ADDENDUM NUMBER 1

DATE: 05/12/2025

PROJECT: City Hall Restroom Renovation

PROJECT NUMBER: 0100-0569

ROOM FINISH PLAN
AND SCHEDULE

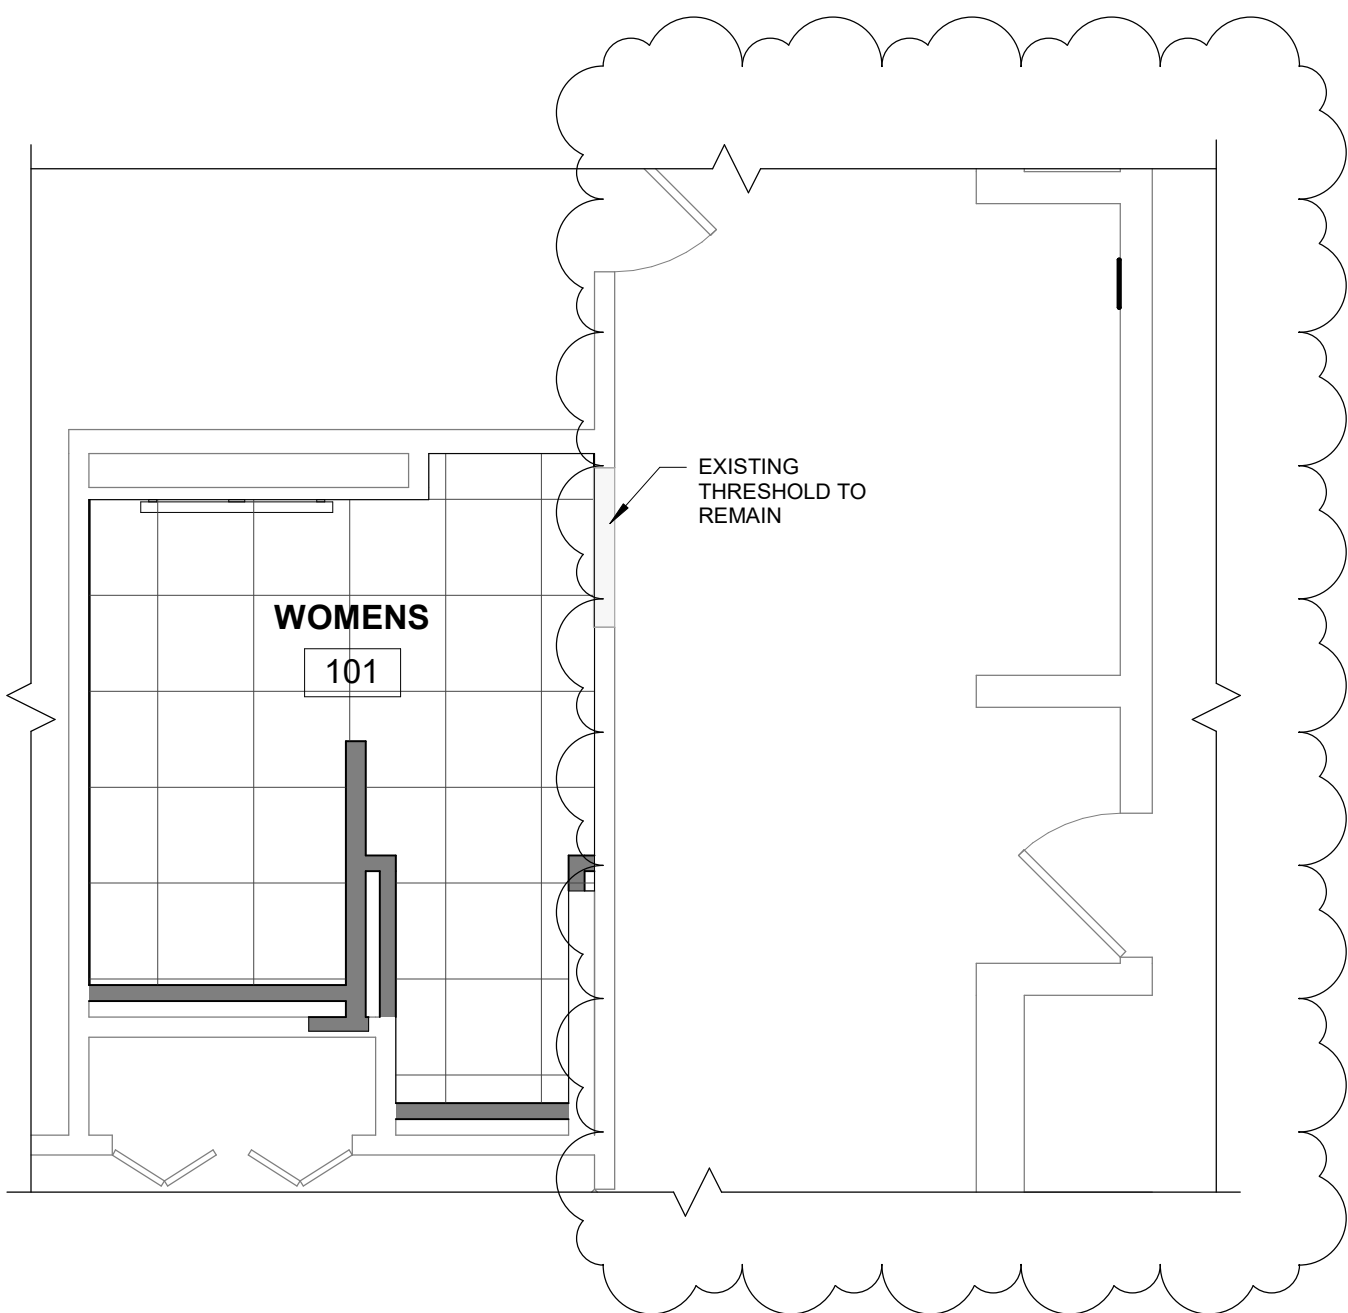
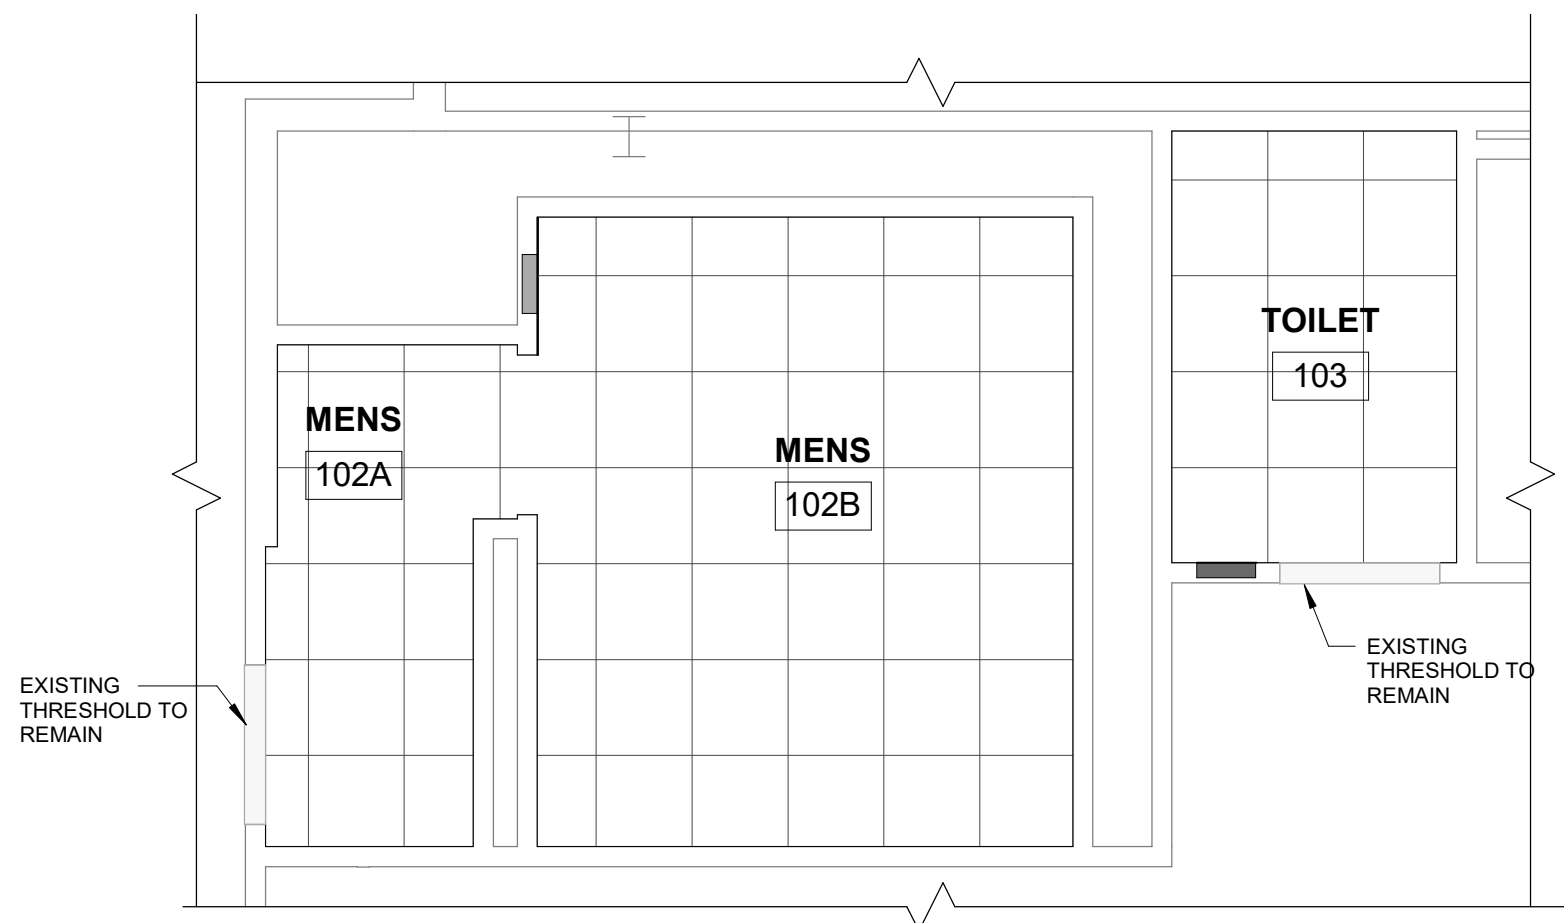
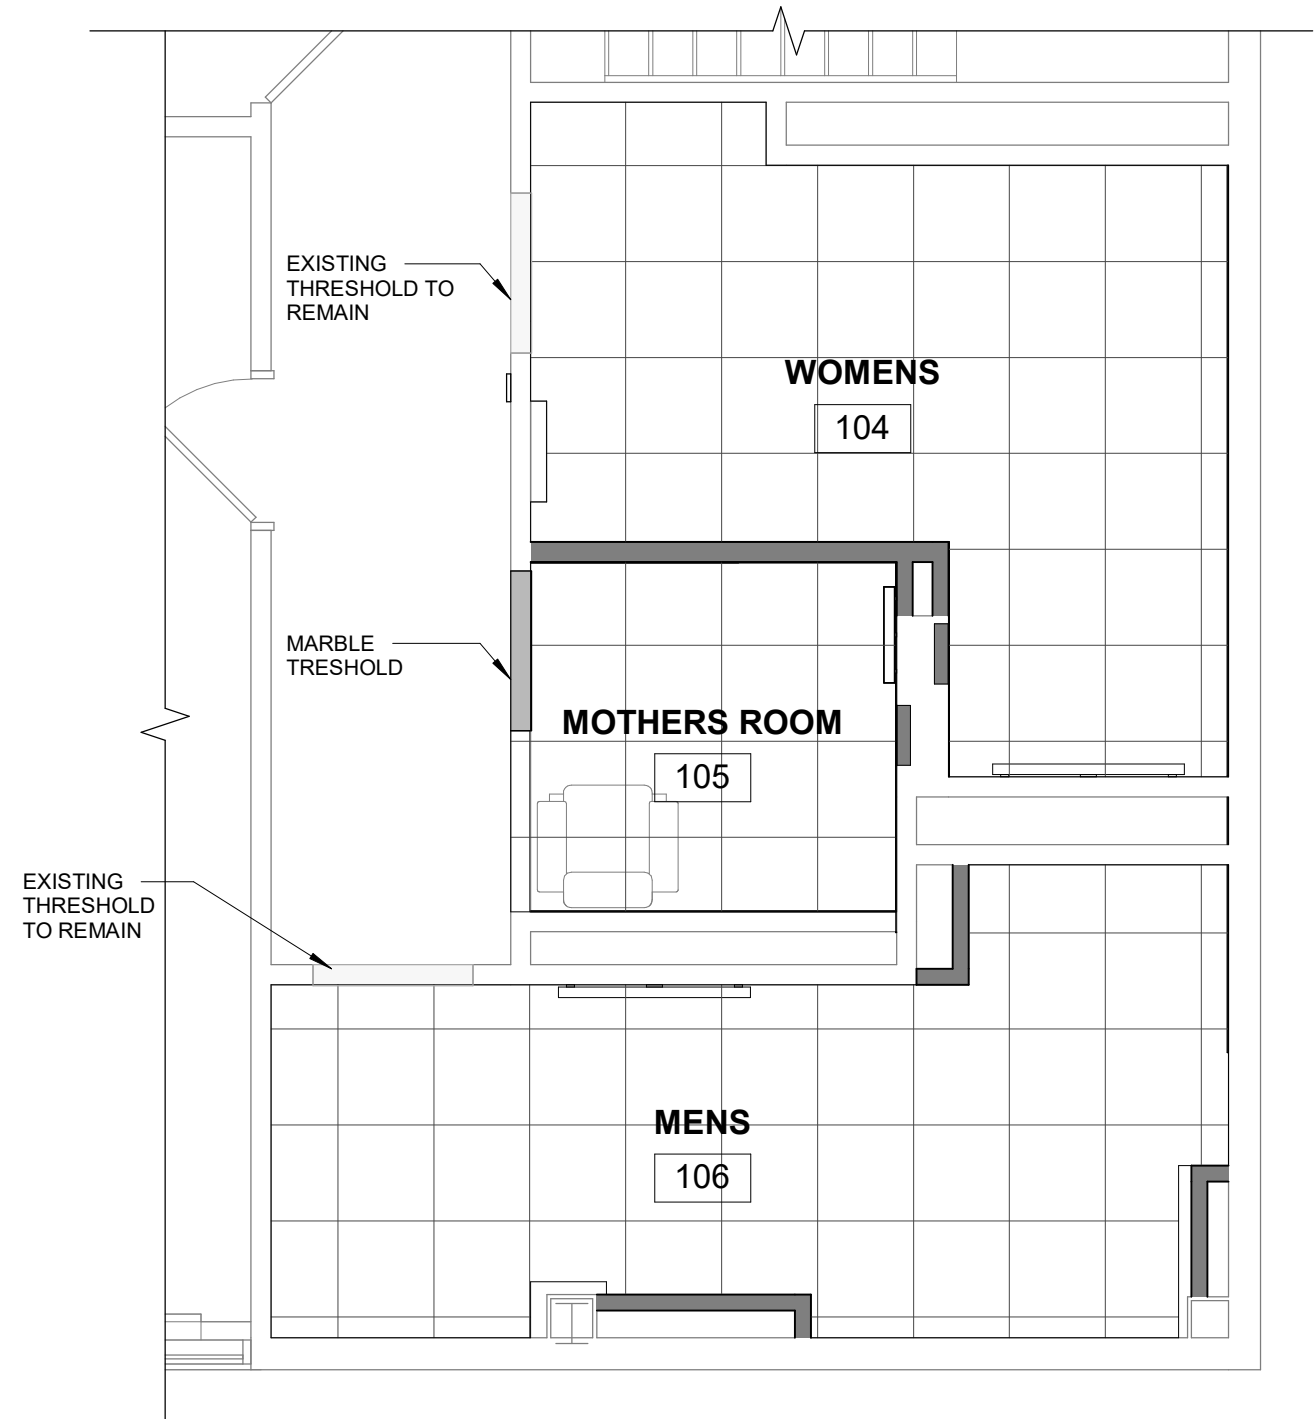
3. **Q:** For the floor tile that has been purchased, who is installing it? Does grout need to be provided?
A: Contractor is responsible for supplying and installing all tile. See updated notes on A611. See updated tile spec on A031.

- a. Room Finish Schedule - all tile to be provided by and installed by GC
- b. Added notes for existing and new thresholds in Finish Floor Plans

PLUMBING PLANS

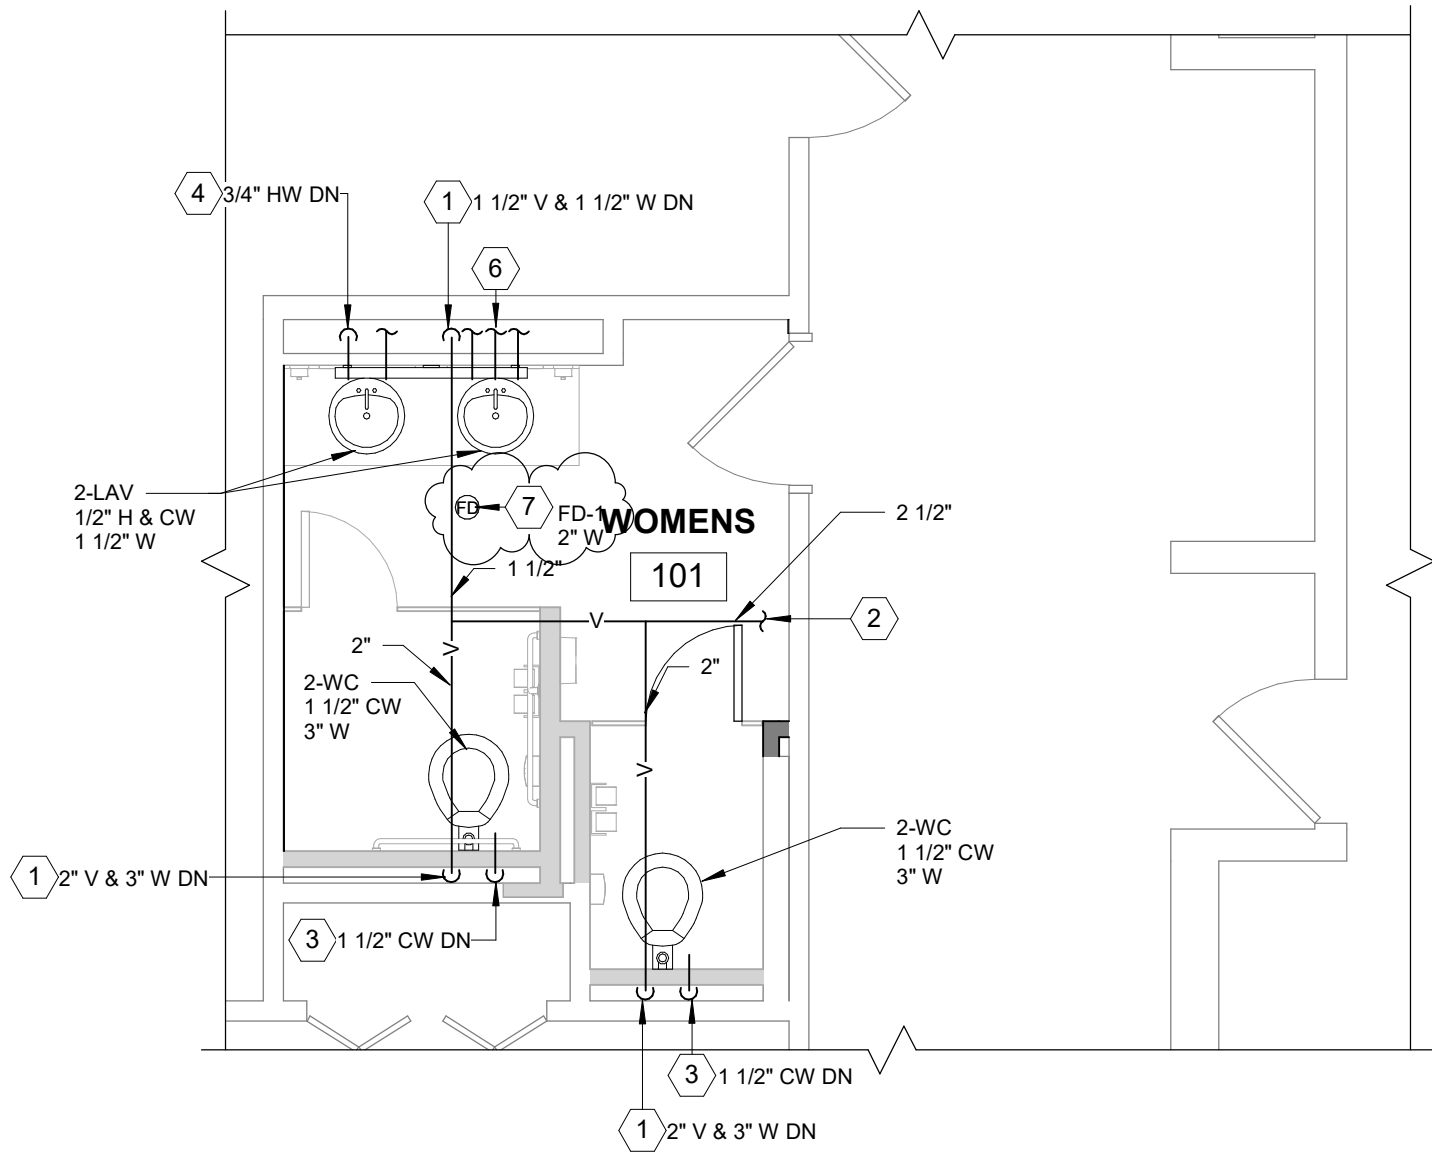
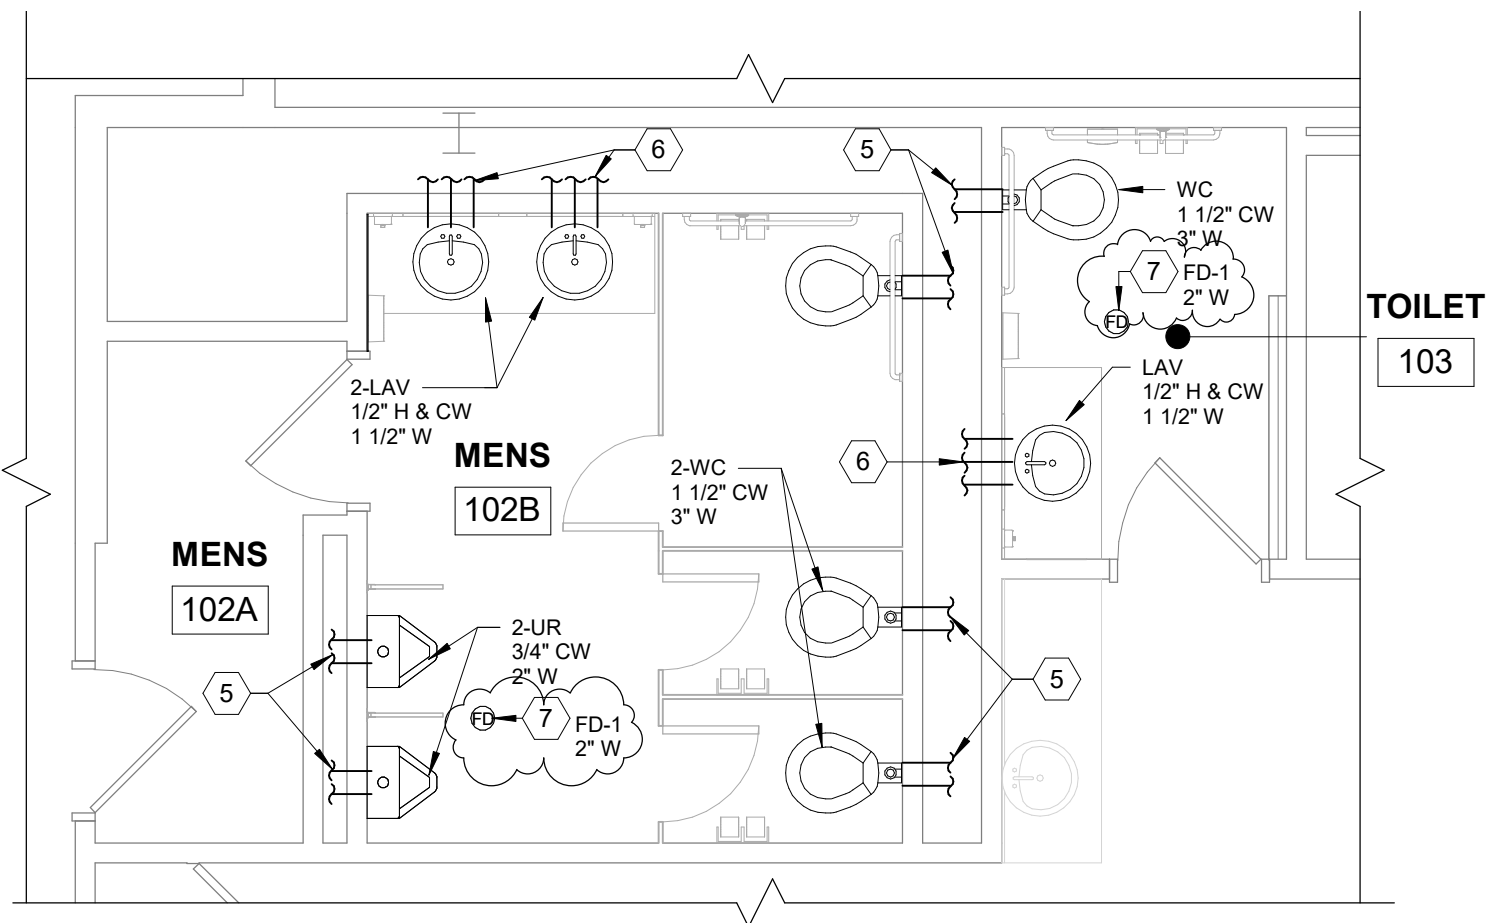
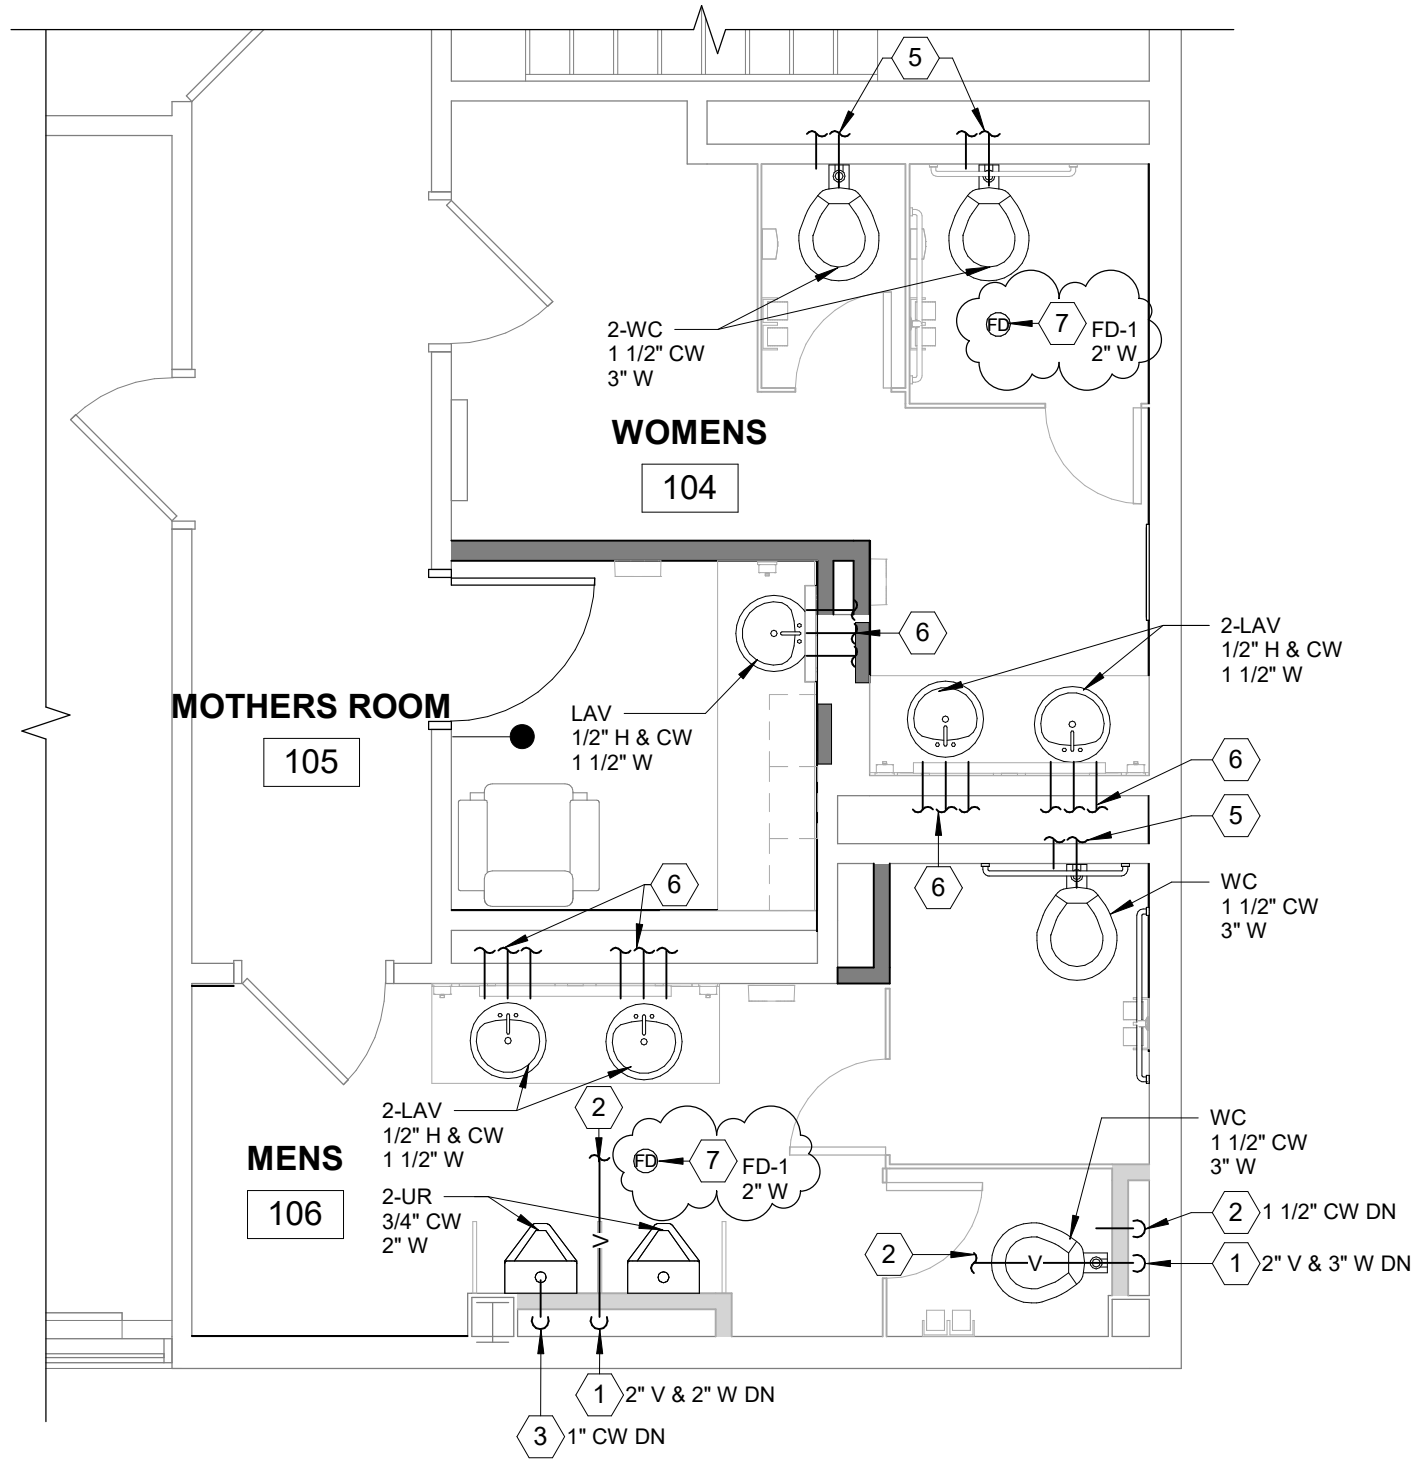
10. **Q:** Existing valves – the building engineer said sometimes the isolation valves hold, and other times they do not. Some have been changed out over the years. There is the potential the immediate branch valves at one of these bathrooms will not hold, and it was noted they would work with us to isolate somewhere else in the system to allow for our work. Should we plan to exclude this since it is an unknown, and then again handle as an extra or via contingency should a valve require replacement?
A: Contractor to include isolation valves as required per updated P101.

21. **Q:** Drawing P01- Indicates the floor drains are to remain, please provide details for floor tile installation at existing floor drains; scheduled floor tile is 12 x 24.

- 1. SHEET P101: reissued
 - a. Added new floor drains
 - b. Added note for required valves

A: Floor drains are to be replaced, see reissued P101 and specifications.

NOTE: INSTALL A MAIN SHUT-OFF VALVE FOR BOTH HOT AND COLD WATER SERVING EACH BATHROOM GROUP. THE SHUT-OFF VALVE SHOULD BE LOCATED IN THE BASEMENT BENEATH THE CORRESPONDING BATHROOM GROUP. ENSURE EACH VALVE IS CLEARLY TAGGED TO INDICATE THE BATHROOM GROUP IT SERVICES. VERIFY THE EXTENT OF WORK IN THE FIELD.
